P-10044-1
X1286
27966

SYMBOL OF QUALITY AN ISO 9001 COMPANY	<b>JINDAL ALUMINIUM LTD.</b> BANGALORE-560073 (INDIA)	NAME		DATE
		DRAWN	J.P.KAUSHIK	23-08-2010
1. ALL DIMENSIONS ARE IN mm. 2. ROUND OFF ALL SHARP CORNERS WITH 0.40 mm. 3. TOLERANCES WILL BE AS PER IS:3965-1981 UNLESS OTHERWISE SPECIFIED		CHECKED		
		APPROVED		S.S.GARG
PARTY'S NAME JANARDAN INDUSTRIES, PUNE		SCALE		2:1
		AREA mm <sup>2</sup>		752.628
PARTY'S DRAWING No. AS PER SKETCH		PERIMETER mm.		251.803
		WEIGHT kg/m		2.032
ALLOY & TEMPER 6061 T6		DRAWING No.		P-10044-1
		SECTION No.		-
DESCRIPTION ANGLE 65		X1286		X1286(ISSUE-3)
		27966		27966

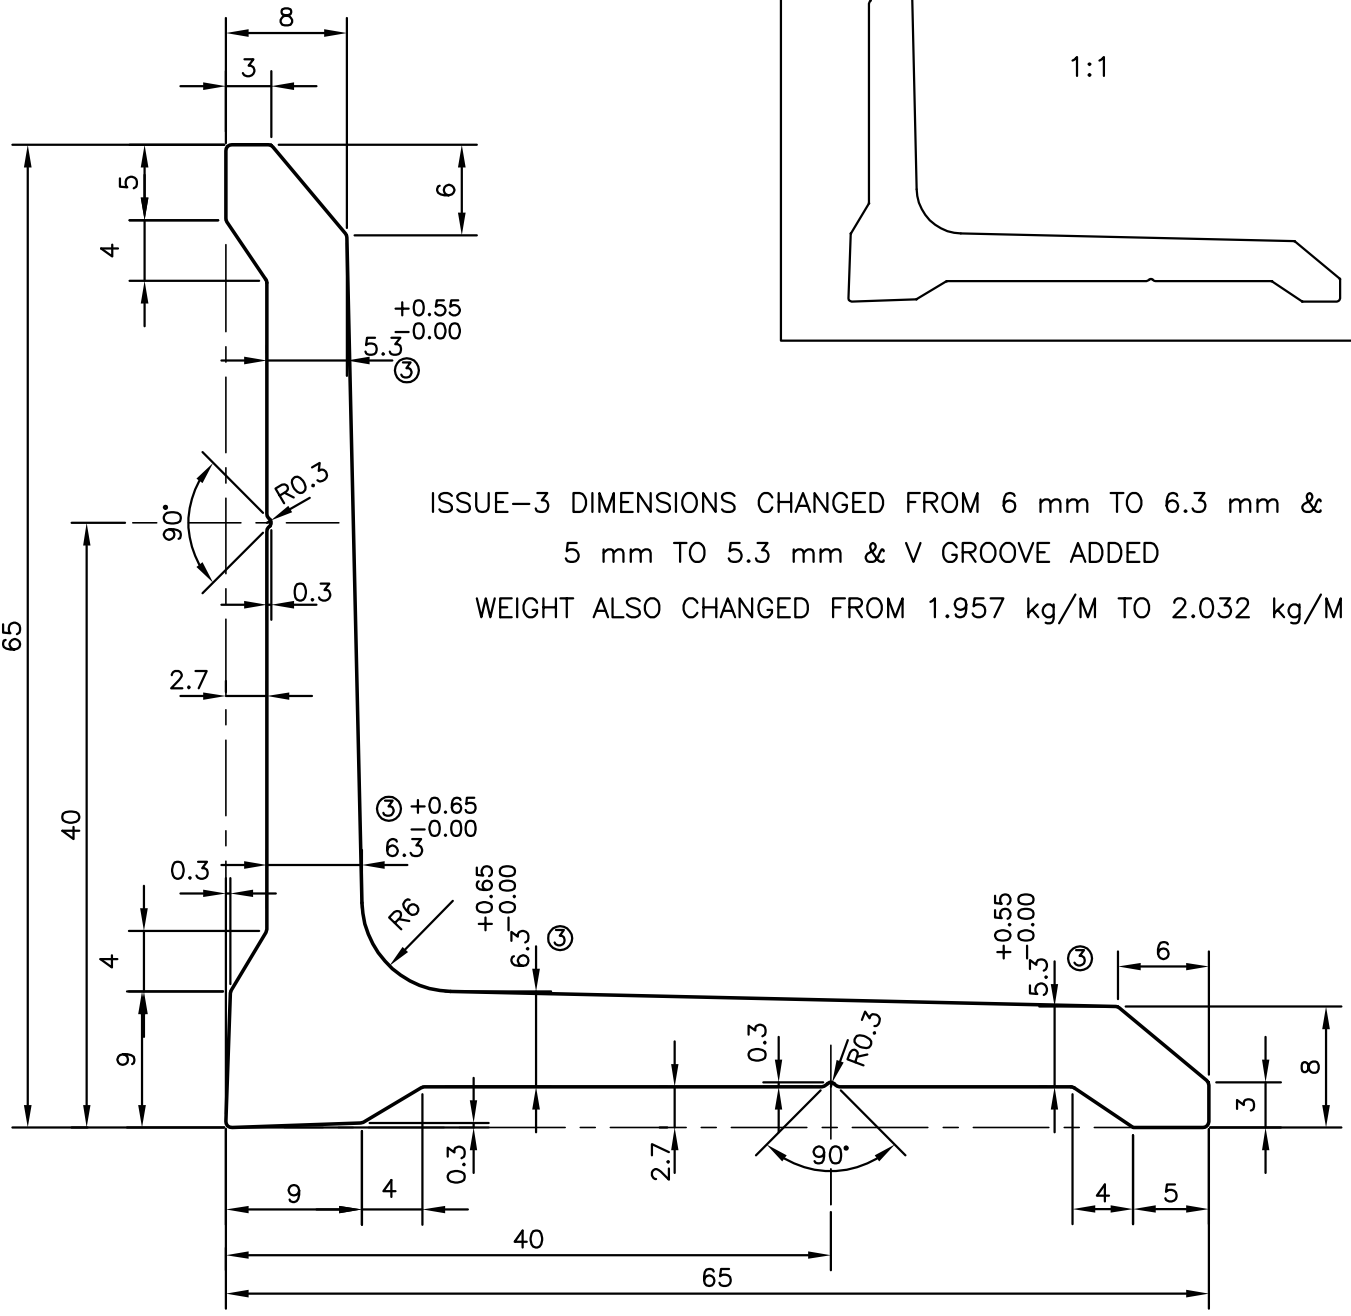
ISSUE-3 DIMENSIONS CHANGED FROM 6 mm TO 6.3 mm &  
 5 mm TO 5.3 mm & V GROOVE ADDED  
 WEIGHT ALSO CHANGED FROM 1.957 kg/M TO 2.032 kg/M

ISSUE-2 TOLERANCE ADDED ON THICKNESS
